Reference: Mining Permit Amendment Request

Re: Request to amend Mine Footprint – Permit Q-8-094

RE: Site Visit, Waste Cell Construction – Permit # Q8-094

RE: Site Visit: Waste Cell Construction – Permit # Q-8-094

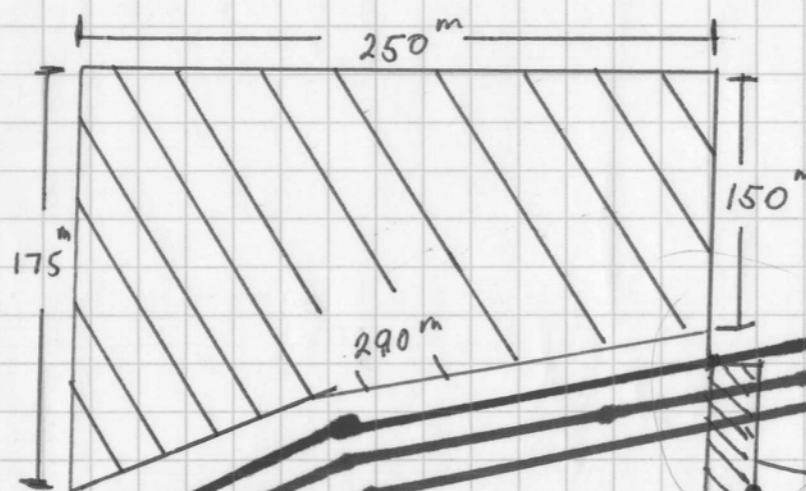
This letter is to request an amendment to our permit No. Q-8-094 Stebbings Road rock quarry. We would like to apply for a section of the mine to be taken out of official footprint. This would in no way be a permanent boundary change and would revert back to an active mine site when non-mining activities are concluded.

Please refer to site plan.

The request is authorized and your mine area has been amended according the submitted mine plan showing that area to be removed. Unless modified by this amendment all conditions of permit Q-8-094 remain in force.
